# **Final Report - Conceptualization of Groundwater in the Glen Rose Formation, Maverick Basin, Texas**

Texas Water Development Board Report 2300012710-2

**January 28, 2025**

**Figure 1.1-2. Location of relevant wells. R-2 wells are oil wells permitted to discharge to surface. P-13 wells are abandoned wells conditioned for water production.**

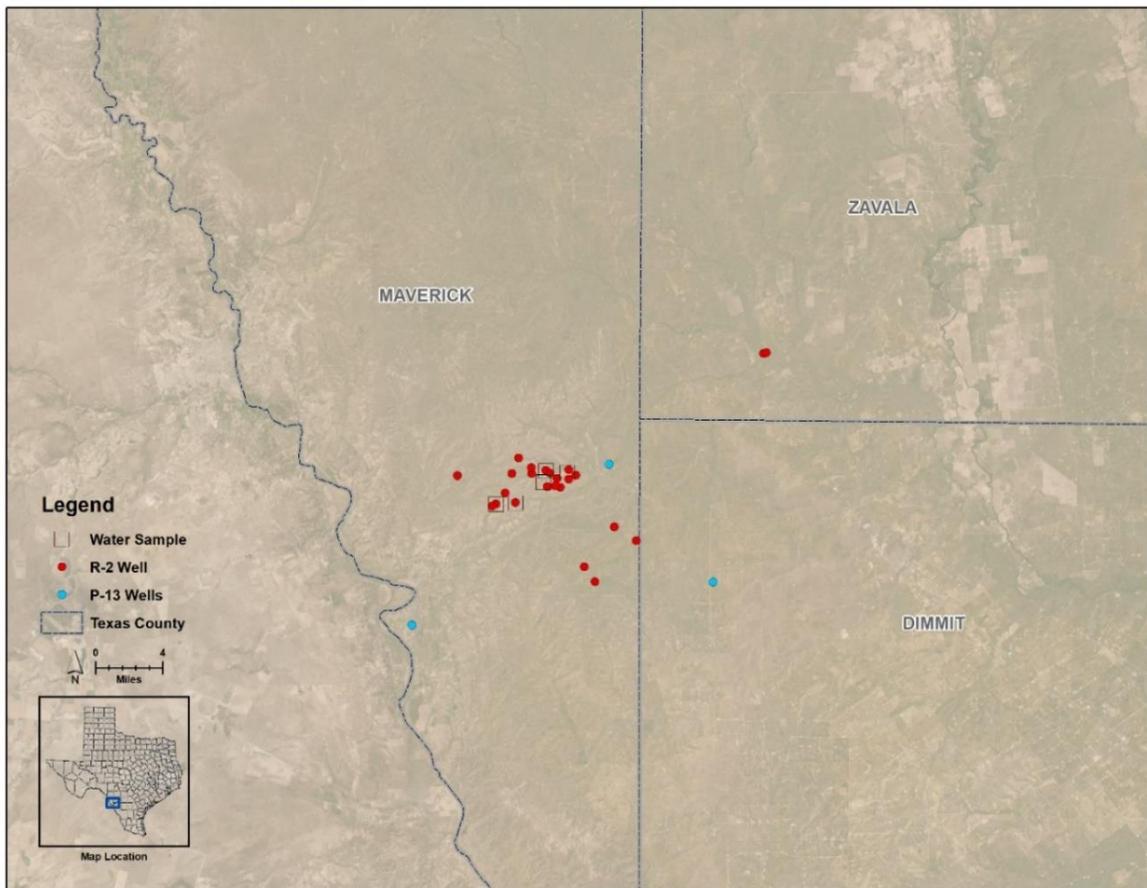
1. Pg. 2, ¶ 1. States “The locations of the wells that were converted to water wells are shown in Figure 1.1-2”. However, no wells have been converted to water wells as of yet, that I know of. Please reword to specify the P-13 wells are applications to convert to a water well, and the R-2 wells are where there is surface discharge of fresh to slightly saline produced water.
  - a. **Done. Reworded.**
2. Pg. 3, ¶ 1. This paragraph is incorrect, the Maverick Basin aquifer is not part of the official Edwards-Trinity (Plateau) Aquifer. It has only been included in the Edwards-Trinity (Plateau) Aquifer brackish groundwater study. Please reword to:

Figure 2.2-2. Seismic line from within the Maverick Basin showing the Chittim Rift, a feature that predates the development of the basin. (Ewing 2016, modified from Scott 2004)

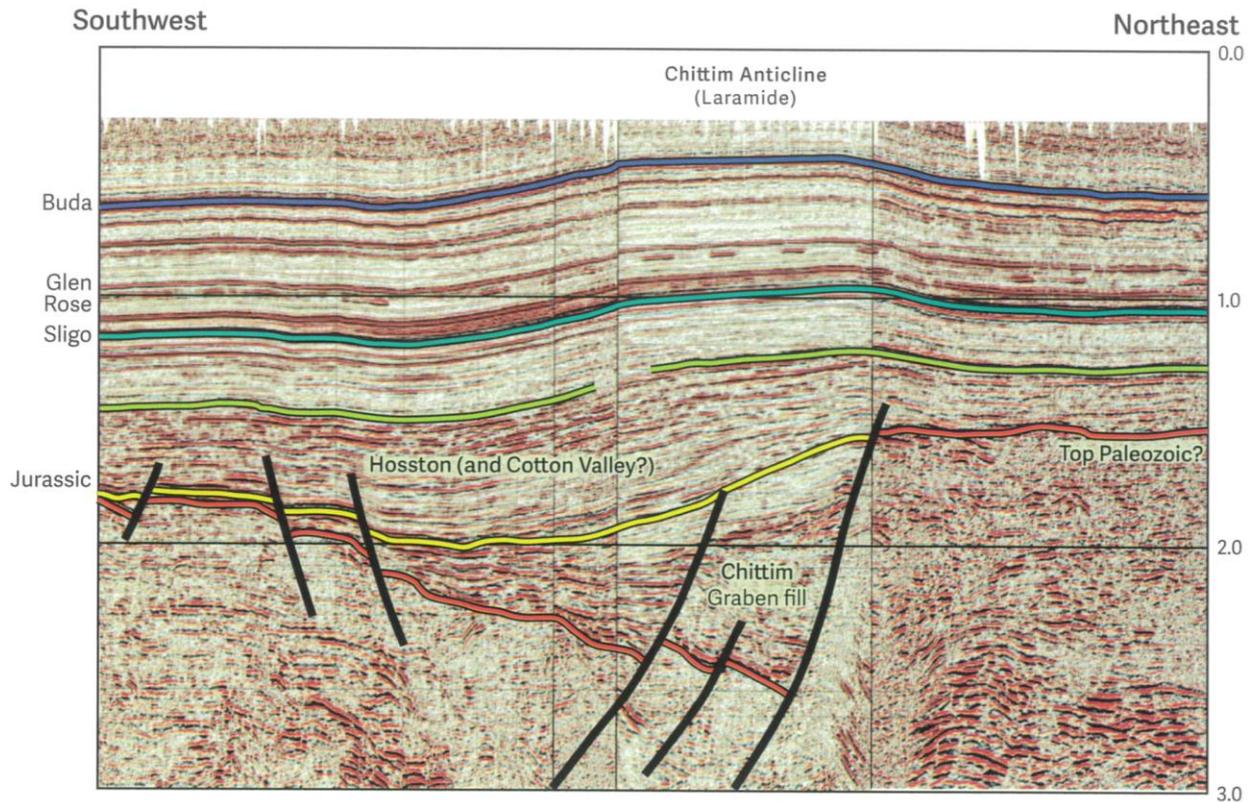
**a. Done.**
14. Figure 2.2-2. In the caption, please clarify which reference the figure came from. Is it Ewing, 2016, modified from Scott 2004?

**a. Done.**
16. Figure 2.2-7. In the caption, please add “; Sligo and equivalents”, like in the previous figures.

Figure 2.2-9. Surface geology of the Chittim Anticline. Modified (Scott, 2004).

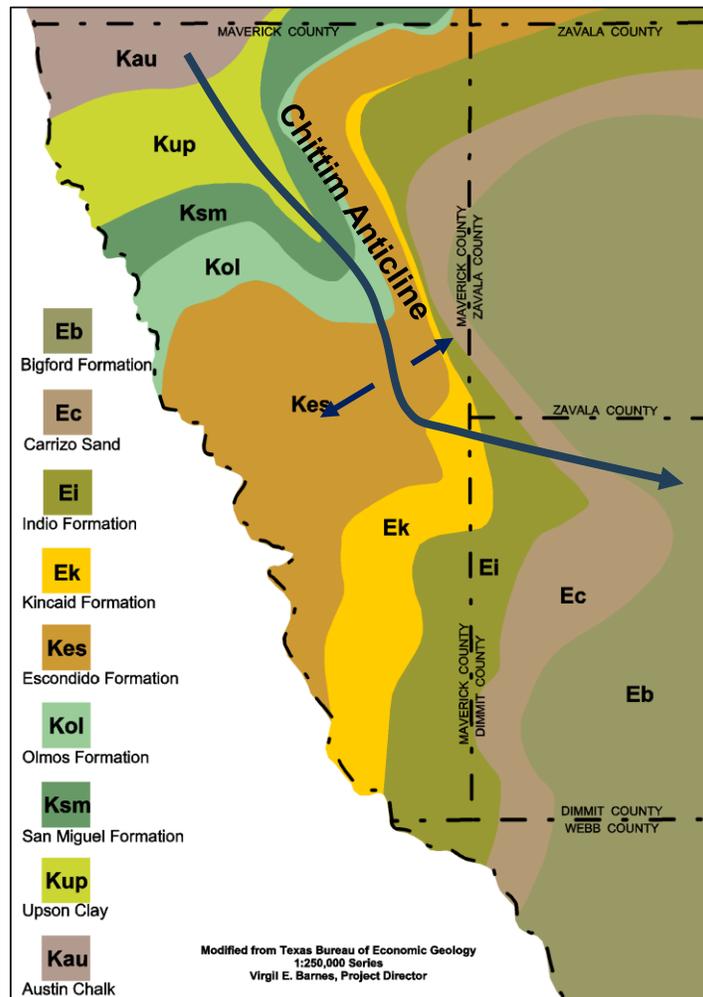
**a. Done.**
18. Figure 2.2-9. It looks like the axial trace of the Chittim Anticline is out of place. Please fix if so.

**a. Fixed.**
19. Pg. 20, ¶ 2, fourth sentence. Please correct “Figure 2.3.2” to “Figure 2.3-2”.

Figure 2.3-7. Mechanisms of emplacement of hydrothermal dolomite (Davies and Smith, 2006).

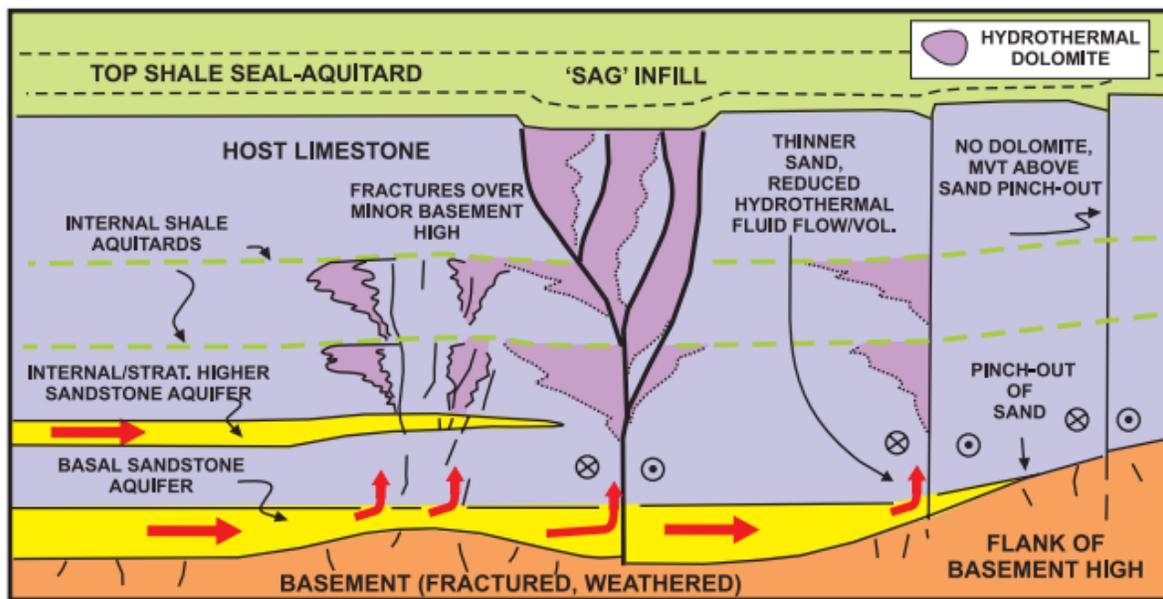
**a. Corrected.**
22. Figure 2.3-7. Please move this figure to after the text in Section 2.3.3 (it can stay on page 30). Currently it appears before it is mentioned in the text.

**a. Done.**
23. Figure 2.3-8. Please spell out “SGM” in the caption.
